Technical change to IE-WL-VL-series (WLAN Access Point/Client/Bridge ValueLine)

- PCN-number: PCN-PN48-20190128-00-A
- date of publishing: 28th January 2019
- revision number: A

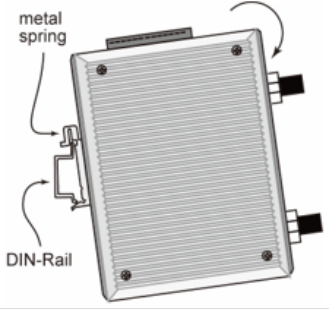
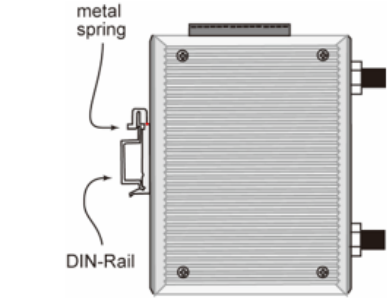
- 1.) Weidmüller will deliver new version of IE-WL-VL-series products with a new default DIN-rail mounting kit. The new kit is designed for better usability and eases the removal of the product from a DIN-rail.

<p>Installing and Removing Current version (2.1.0)</p>	<p>STEP 1: Insert the top of the DIN-Rail into the slot just below the stiff metal spring.</p>  <p>STEP 2: The DIN-Rail attachment unit will snap into place as shown below.</p> 		
<p>To remove the Wi-Fi device from DIN-rail, simply reverse Steps 1 and 2.</p>			
<p>Installing and Removing New version (2.2.0)</p>	<p>Mount STEP 1: Insert the upper lip of the DIN-rail kit into the mounting rail.</p>	<p>Mount STEP 2: Press the WLAN device towards the mounting rail until it snaps into place.</p>	<p>Remove: Step 1: Pull down the latch on the DIN-rail kit with a screwdriver. Step 2/3: Slightly pull the WLAN device forward and lift it up to remove it from the mounting rail.</p>
